Project Title
Walmart SUPERCENTER #1301-02
© CLEARBROOK VILLAGE SHOPPING CENTER
ROANOKE COUNTY, VIRGINIA
BY: WAL-MART REAL ESTATE BUSINESS TRUST
BENTONVILLE, AR

DRAWN BY RD
CHECKED BY BGL
DATE 9/21/2009
SCALE 1" = 60'
JOB No. 08-203
SHEET NAME

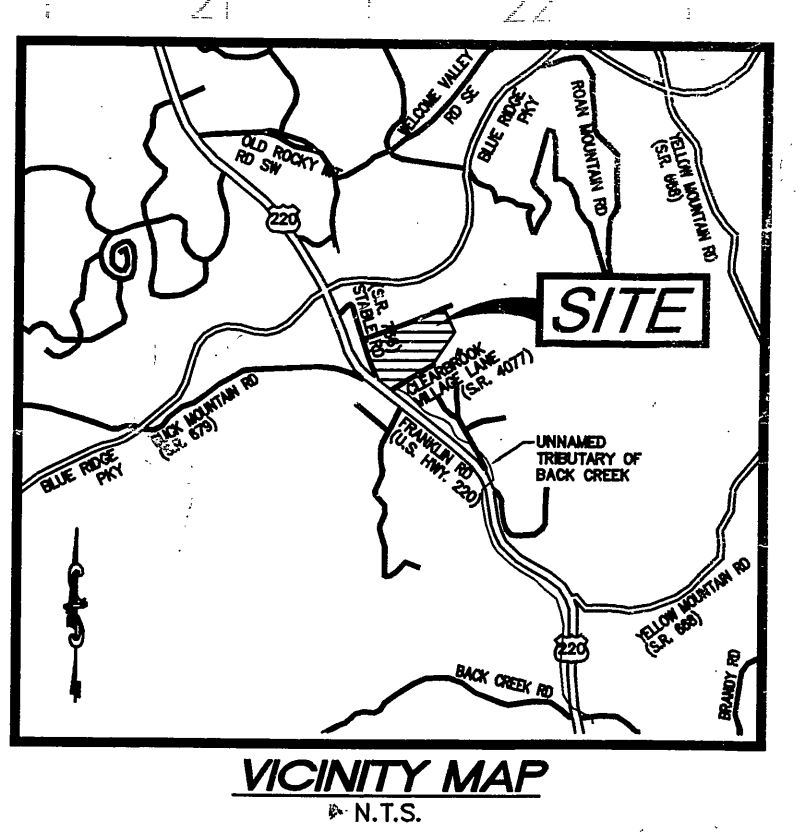
Severe
Tested from MH 2 to MH 5. It passed
Tested from MH 5 to MH 6. It passed
Tested from MH 6 to MH 7. It passed
Tested from MH 7 to MH 8. It passed
Tested from MH 2 to MH 3. It passed
Tested from MH 3 to MH 4. It passed
All manholes passed

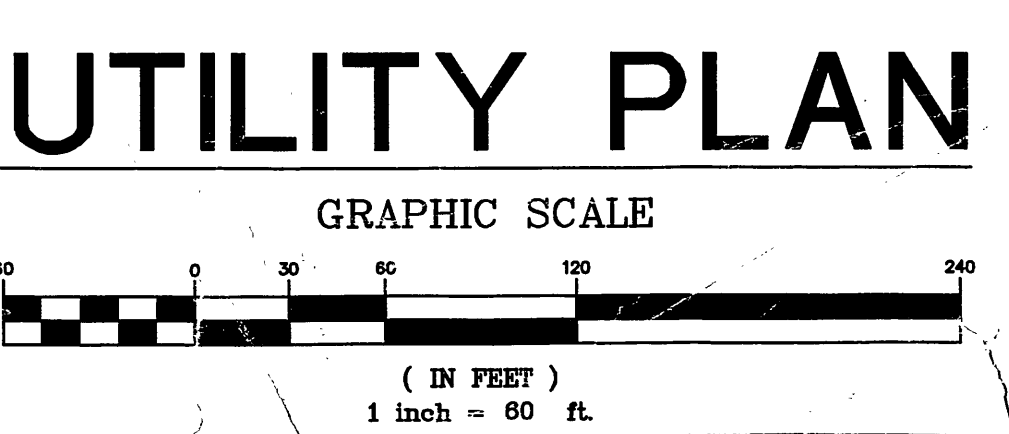
Tested 12" water main from 12" top to where it ties in with the 8". 4/27/10
Ken told the sat of 12" water main. 8/23/10
